From: Sarah Burrow <[REDACTED]>
Sent: 03 June 2020 09:11
To: Amber Willard <[REDACTED]>
Cc: Chris Slade <[REDACTED]> Luke Honeywill <[REDACTED]> Planning.Responses
<Planning.Responses@arun.gov.uk>
Subject: FW: BN/17/20/DOC - 3 Oriel Close

C1375_100_P1_SW Drainage Layout
SW_Network_1_A

Consulting Civil Engineers					
CLIENT MR JAMES TAYLOR					
ARCHITECT CRITCHLEY ARCHITECTURE AND DESIGN LTD					
JOB TITLE 3 ORIEL CLOSE BARNHAM					
DRAWING TITLE SURFACE WATER DRAINAGE LAYOUT					
DRAWN	LH	ENGINEER	CS	CHECKED	APPROVED
DATE	MAY 2020		SCALE @ A1		1:100
JOB No.	C1375	STATUS	P	DRAWING No.	100
				REV	P1

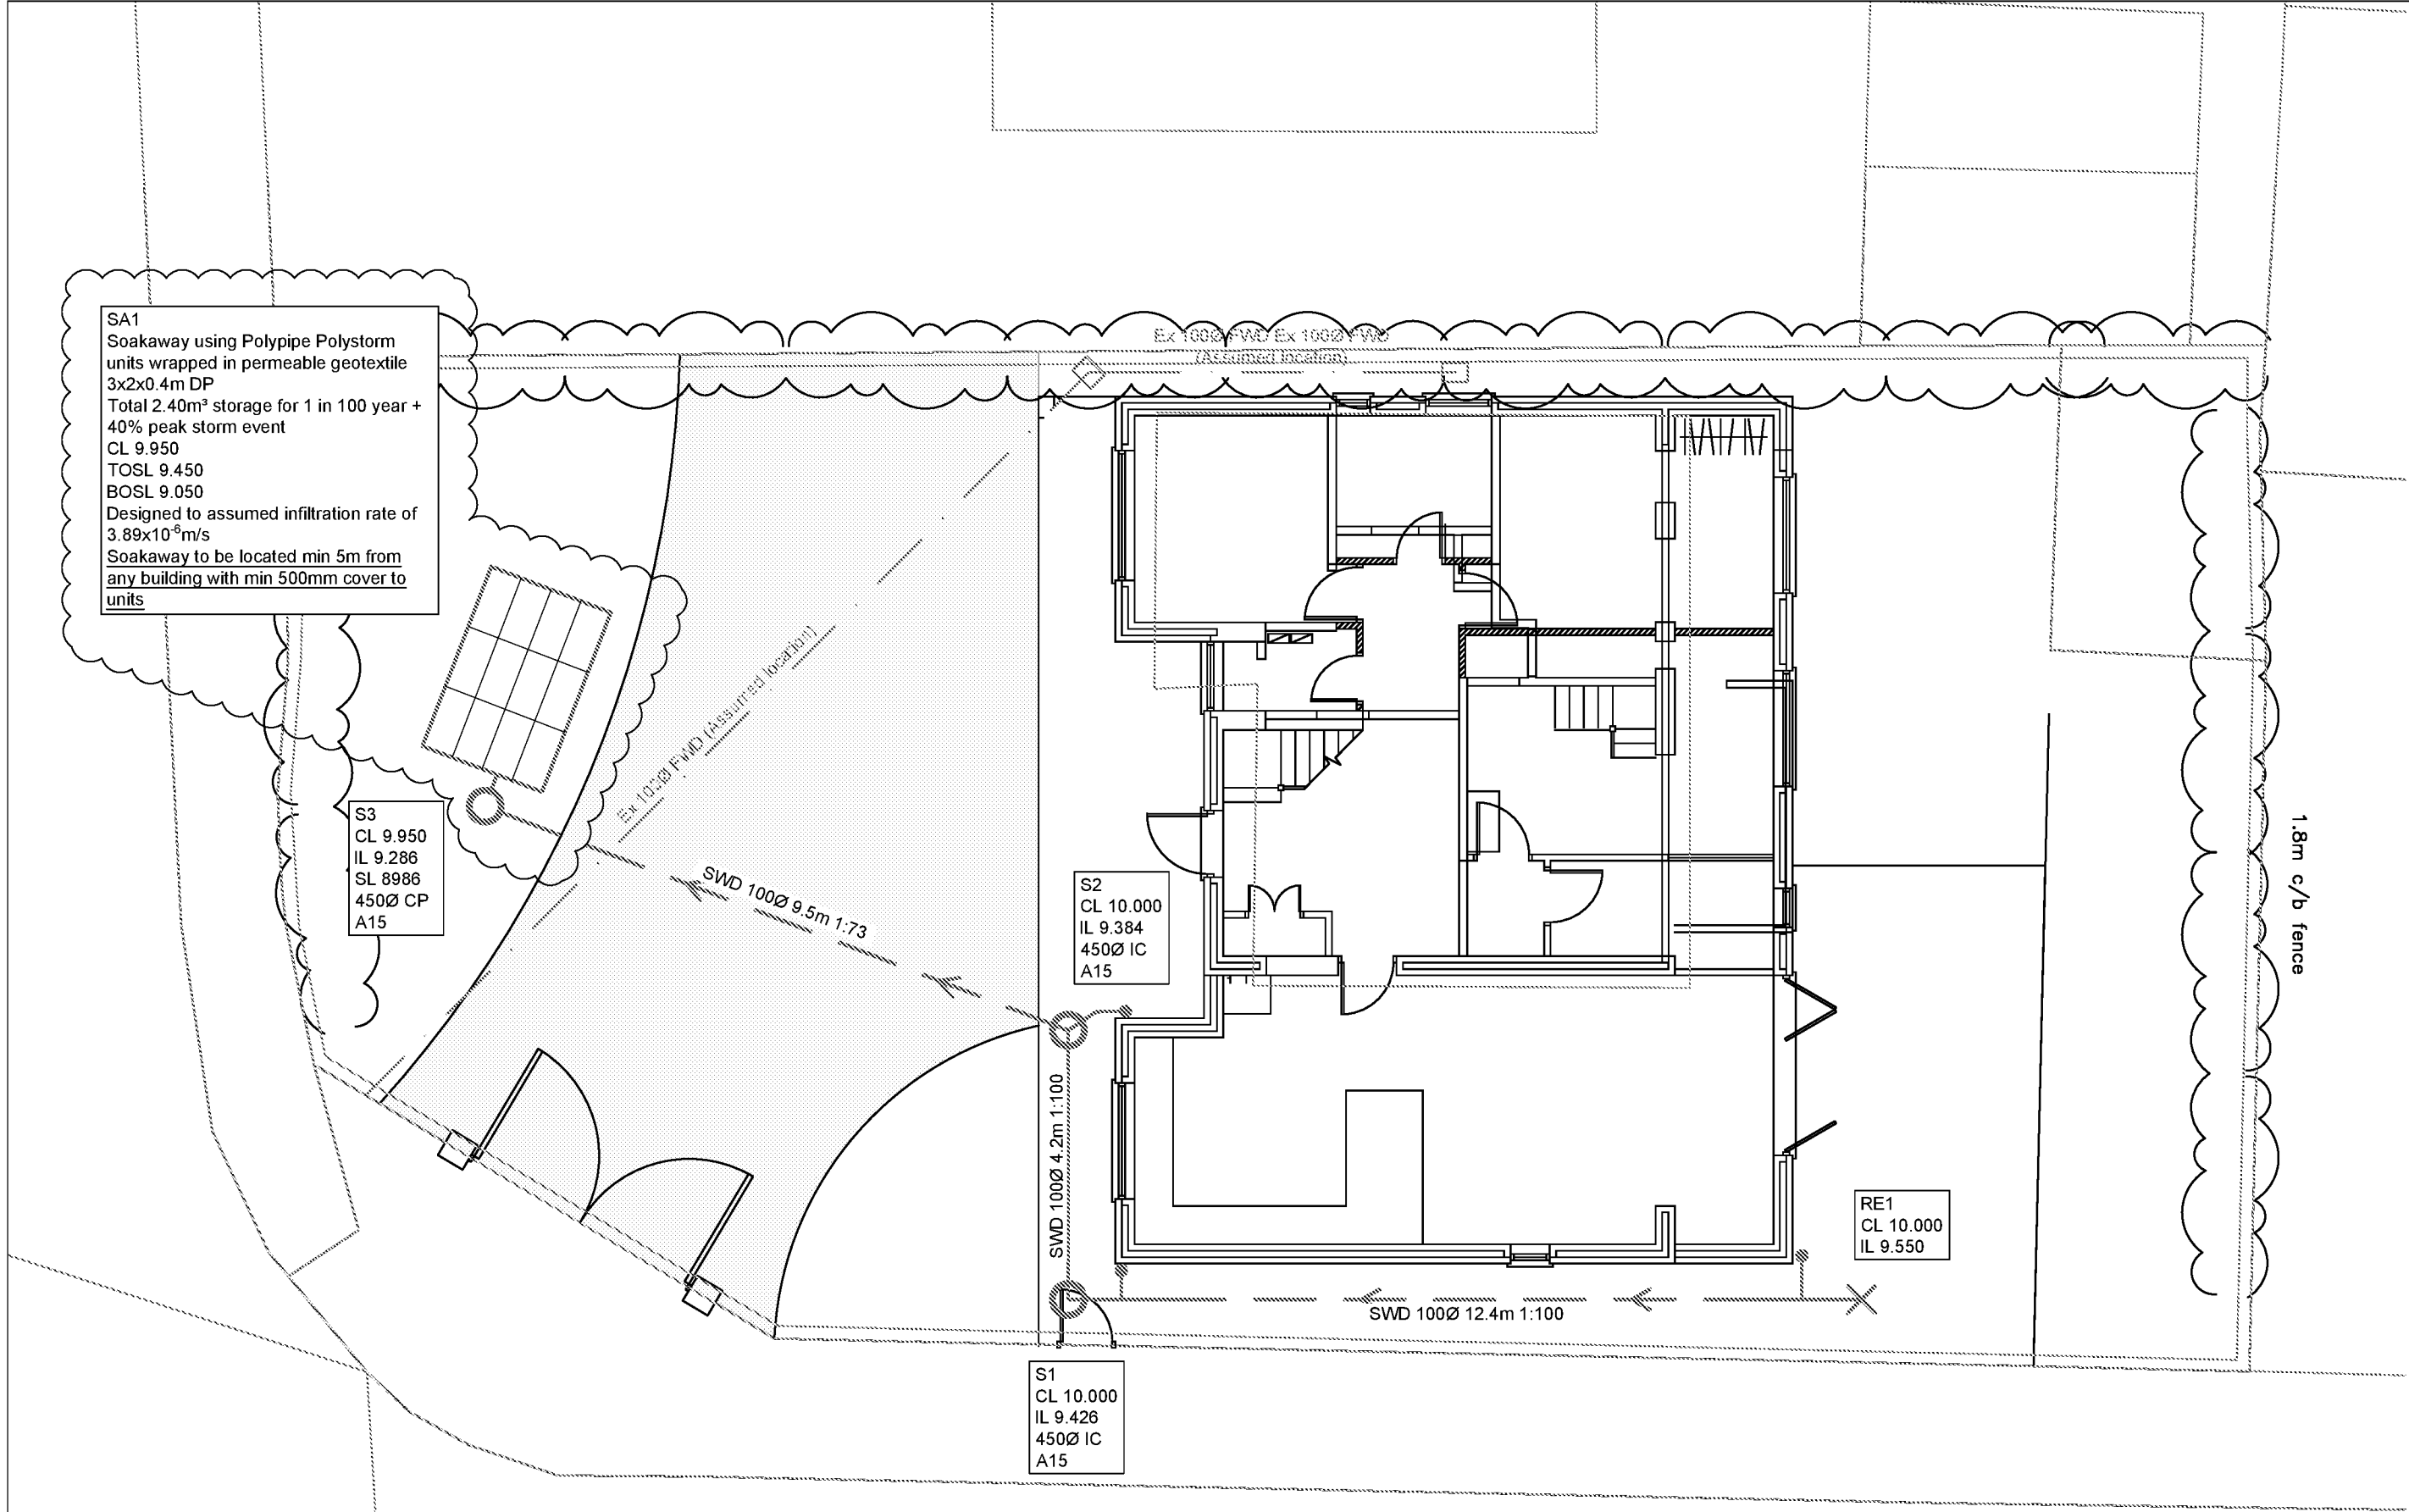
As discussed I think you are going to have to use a more conservative infiltration rate for the calculations which will result in a larger soakaway.

The original application states

“Dispersal rate from on site percolation testing
300x300 pit, 320 mins to drop 150mm 0.014M³/M²/h” [sic]

On this basis I'd assume the infiltration rate to be 3.89 x 10⁻⁶m/s. However I questioned this rate at the time as the date of testing was not supplied, nor was it clear the depth of the pit or number of fills. I would have expected a factor of safety of three to be applied to this rate if the further information could not be supplied. Given the potentially very high groundwater and the ambiguity on the site the additional capacity is necessary.

The drainage layout and details otherwise are fine. If you can get a design in today I will assess again to get a response to Amber tomorrow morning.

The client's Engineer forwarded me a revised Drainage Layout and Calculations yesterday after I raised concerns about the infiltration rate used. On the basis of the calculations and plan attached to this e-mail (listed below) I am happy to recommend you discharge Condition 3 on application BN/92/19/HH.

Many thanks for looking at this so quickly. Please find revised drawing and calcs attached.

P1	02.06.20	REVISED TO SUIT ARUN DC COMMENTS	CS	CS	CS
P-	27.05.20	PRELIMINARY ISSUE	LH	CS	CS
REV	DATE	DESCRIPTION	BY	CHK	APP
